**DRAFT FOUNDATION INVESTIGATION AND DESIGN REPORT
FOR
PROPOSED PICKEREL AND JACK LAKE ROAD UNDERPASS
STRUCTURE SITE NO. 44-399
DISTRICT 52, HUNTSVILLE
W.P. 473-93-00**

**August 1999
TT98820E**

To: V. Minassian, P. Eng.
Senior Project Engineer
Planning and Design, Northern Region

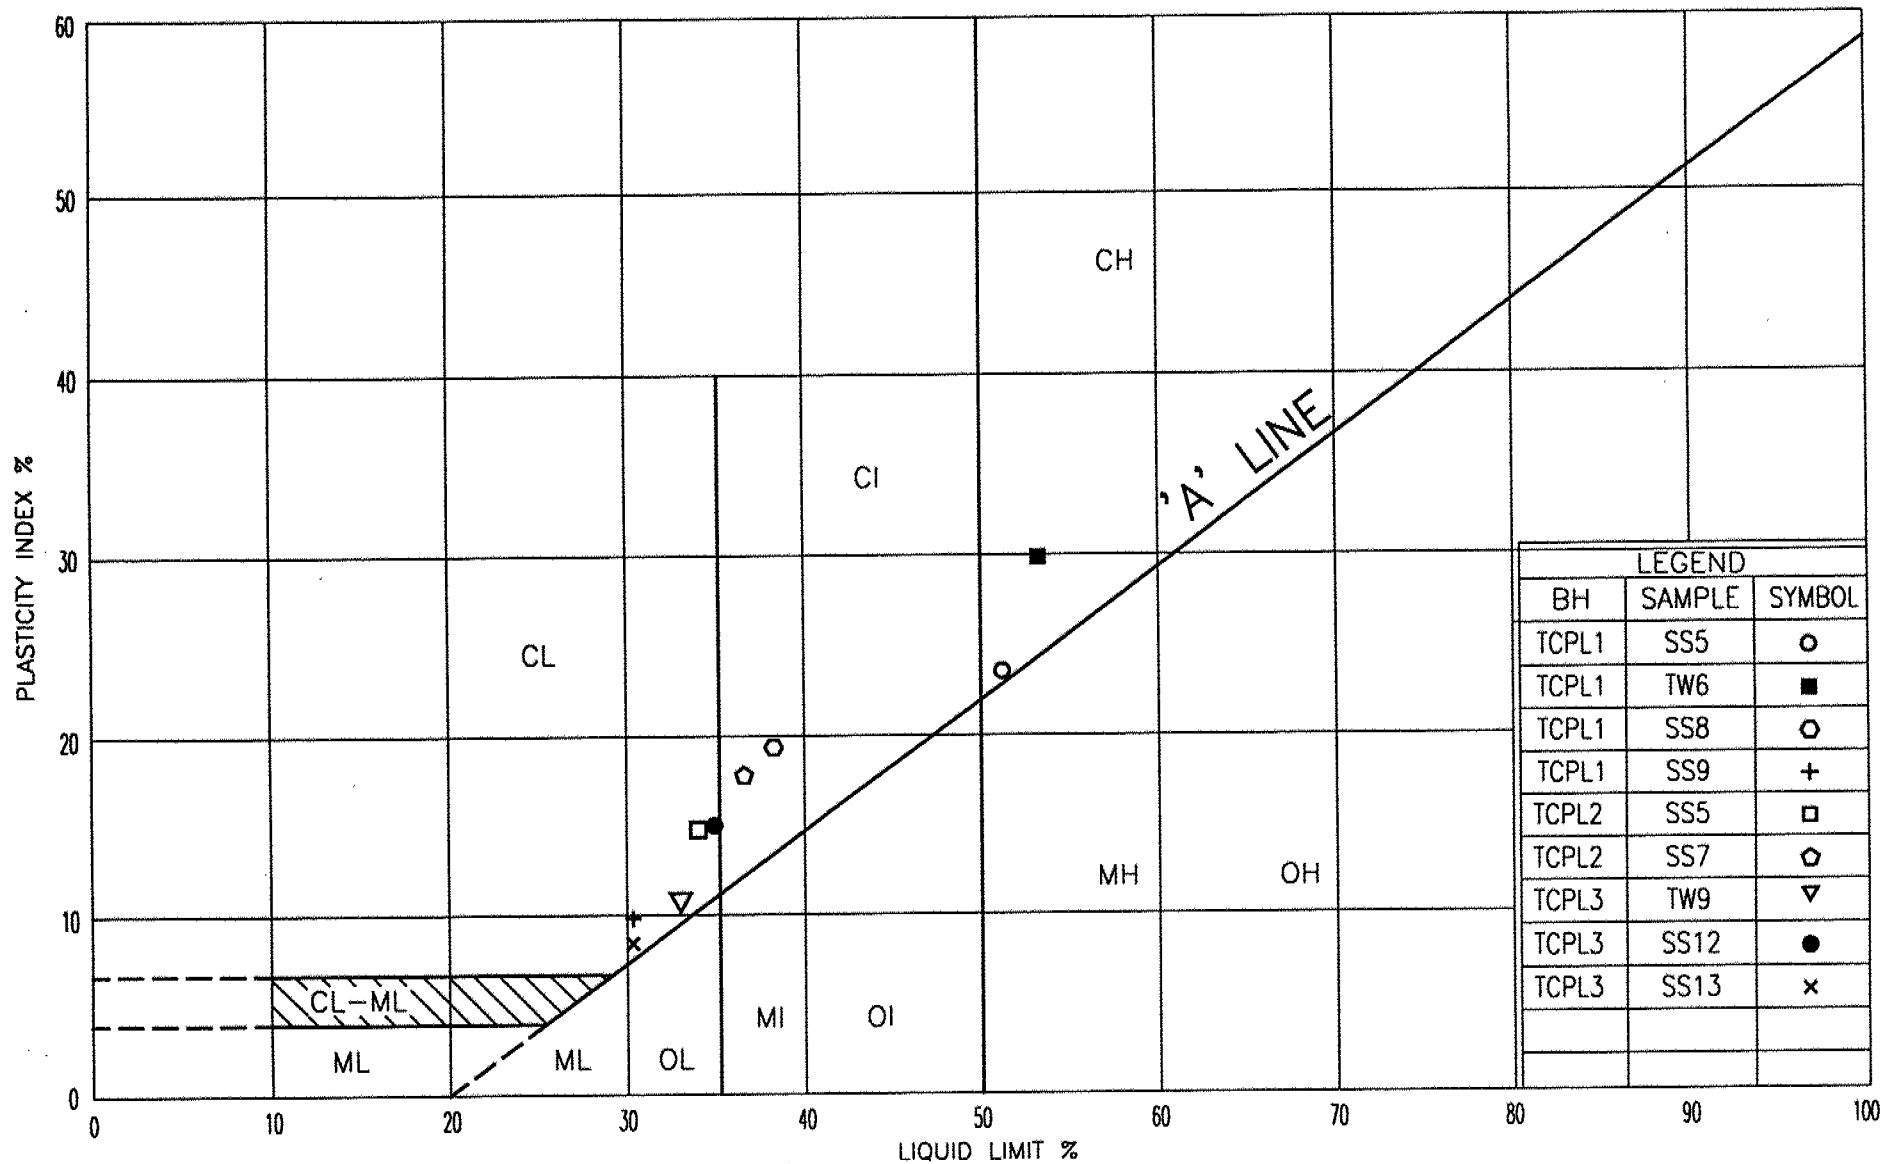
Based on our observation of the behaviour of the soil as illustrated on Figure 7 and as indicated in the report, the soil is of low to intermediate plasticity. Consequently, the soil is not described correctly and should be described as Clayey Silt to Silty Clay.

FIG No 7

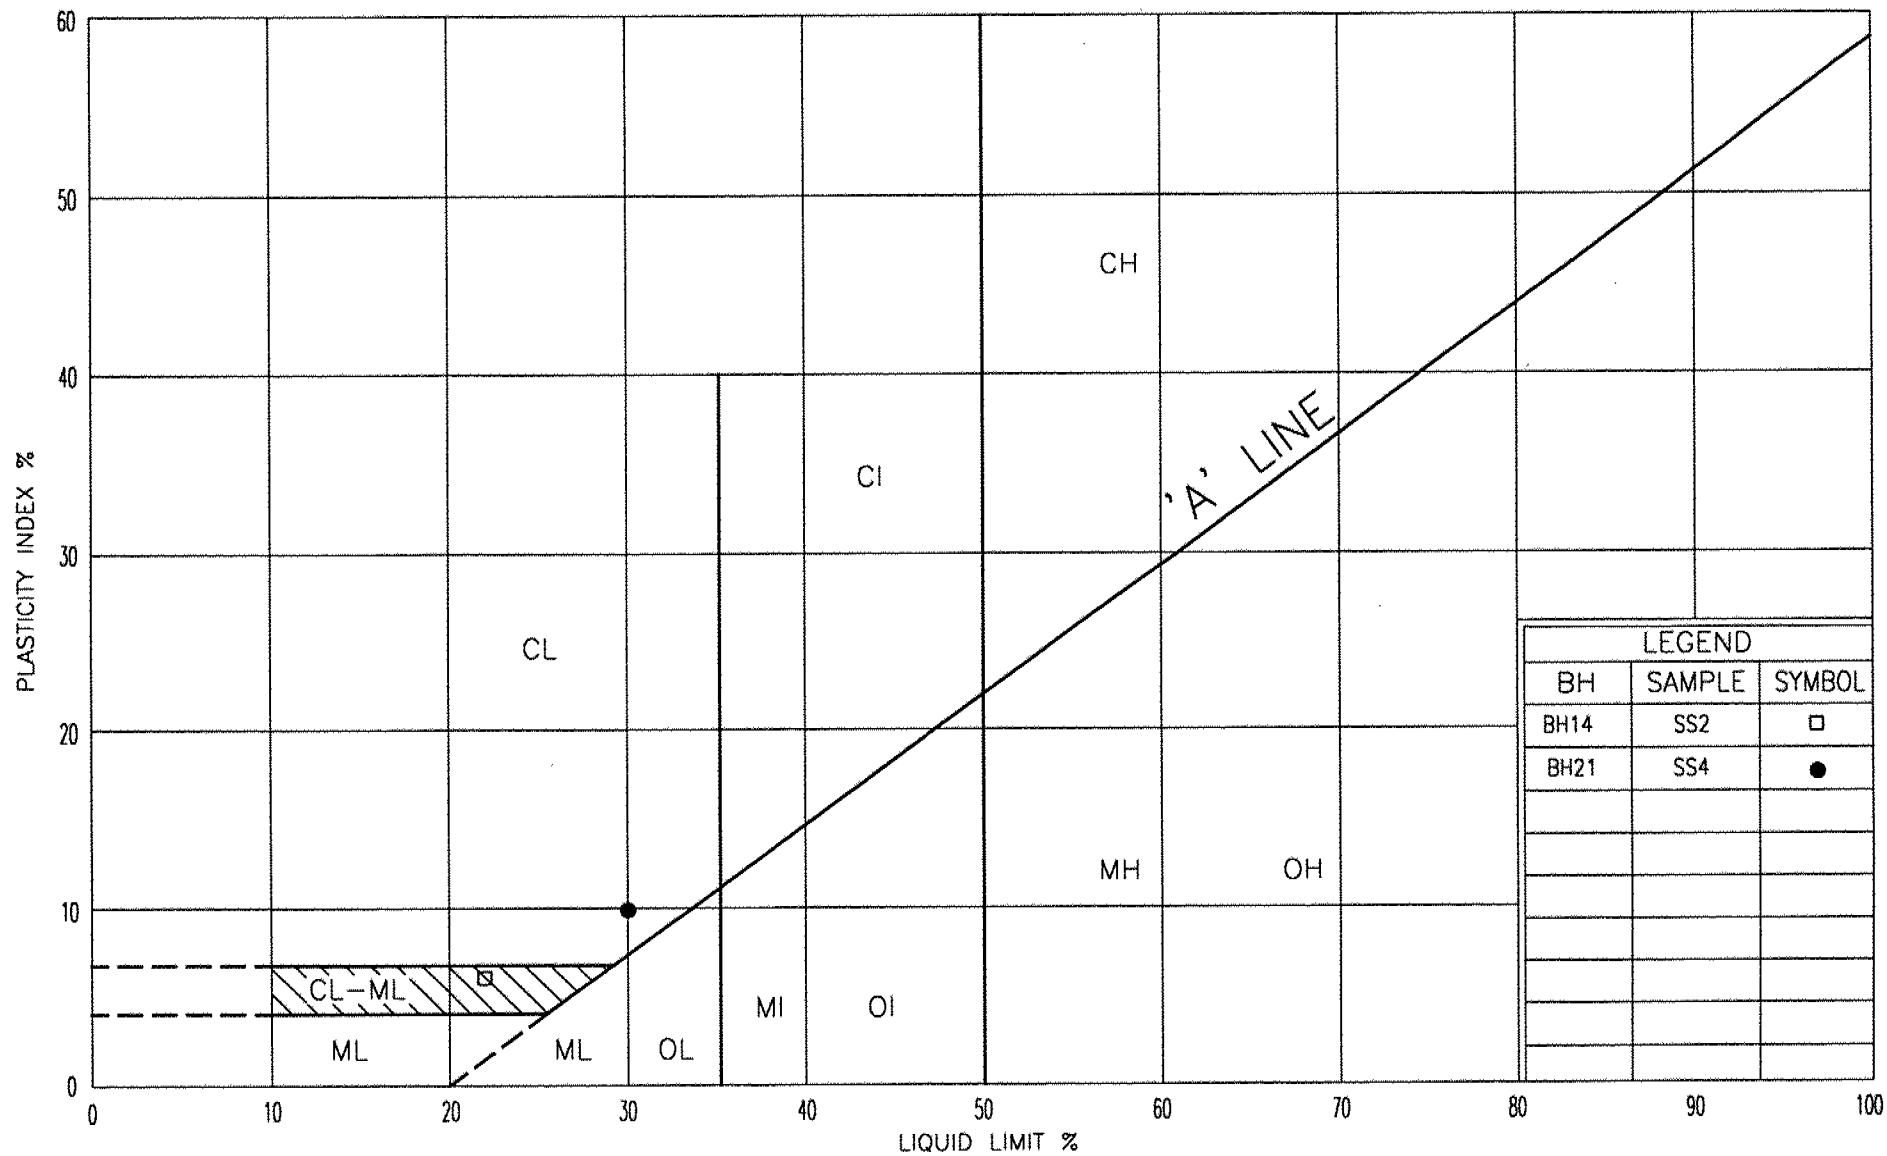
Figure 7 illustrates that the cohesive material is of low plasticity (CL to CL-ML). Consequently, the material should be described as clayey silt rather than clayey silt to silty clay.

FIGURE NO. 7
W P 473-93-00

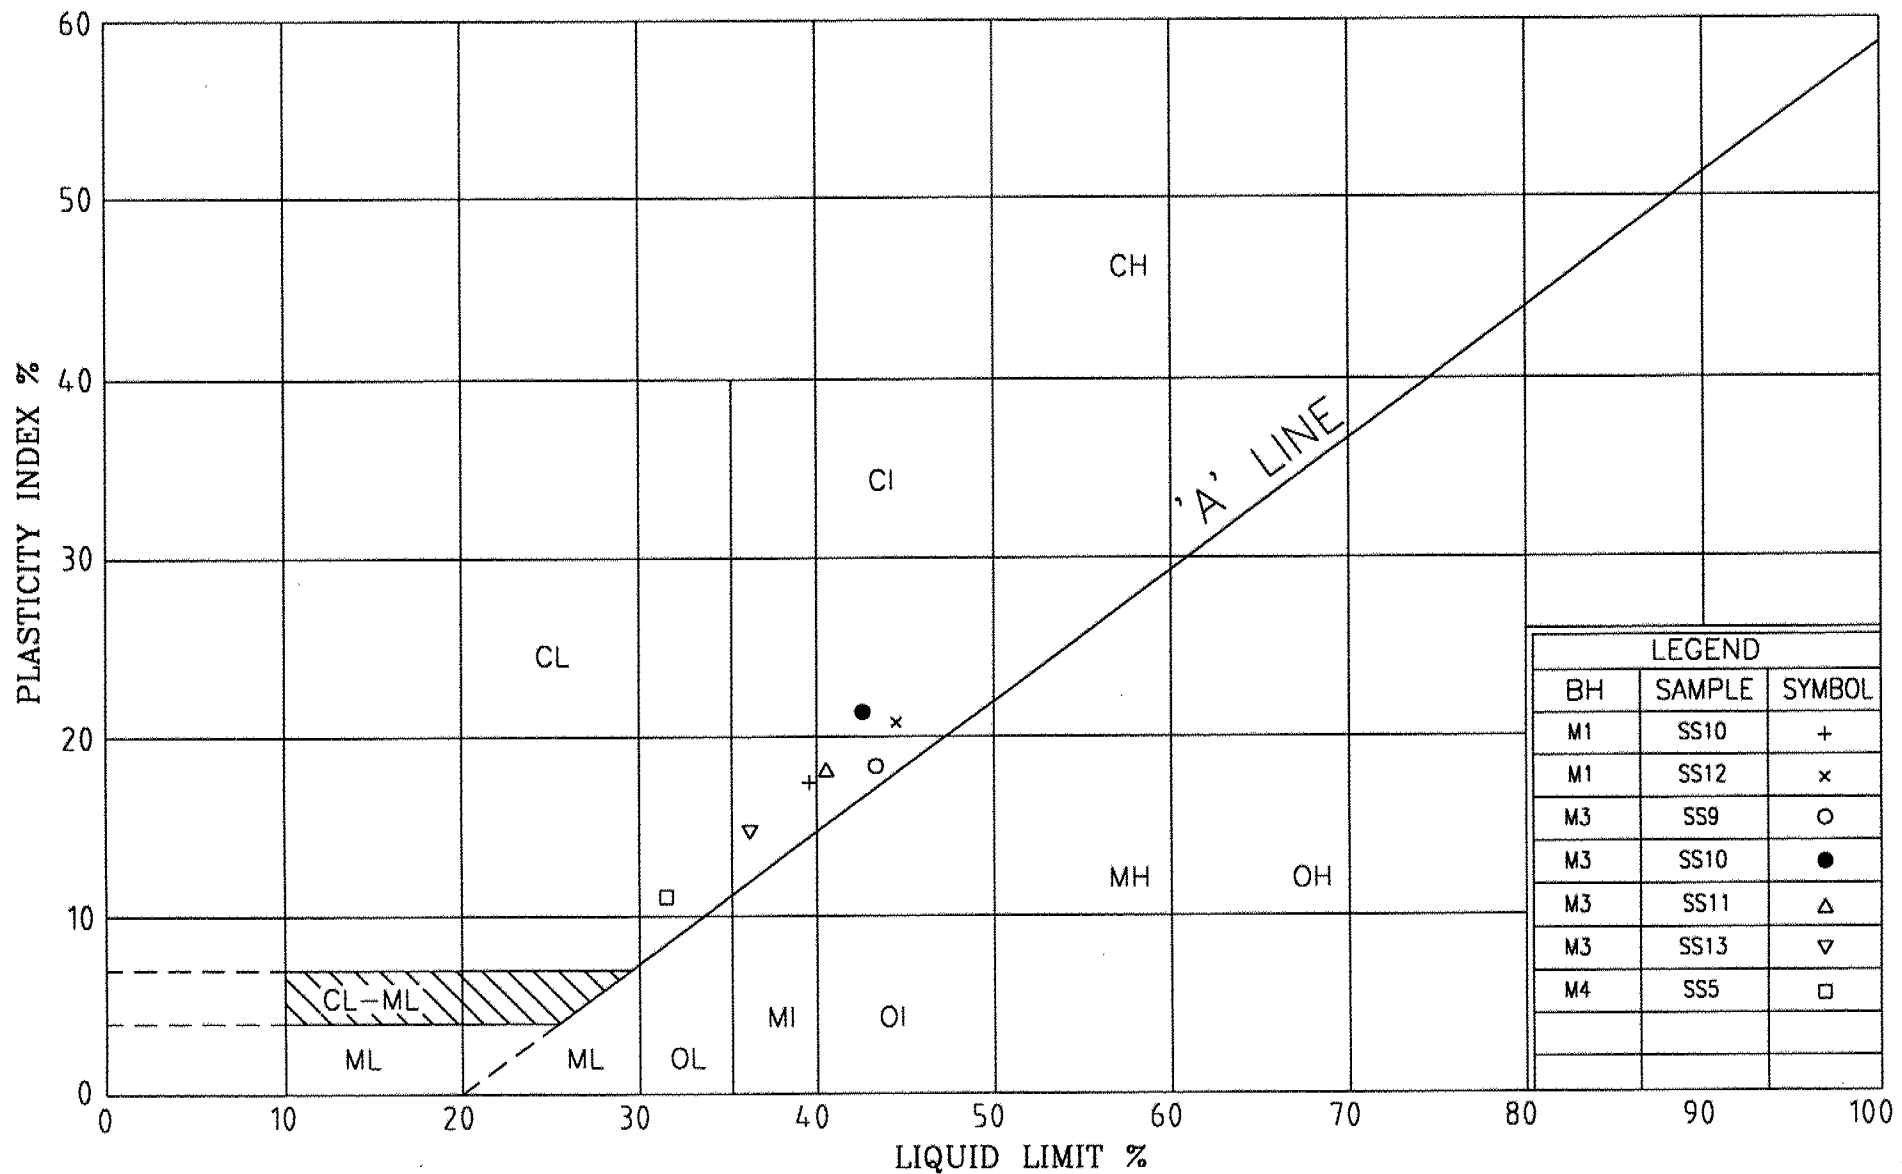
Figure 8 illustrates material of low plasticity (clayey silt) and not intermediate plasticity (silty clay).
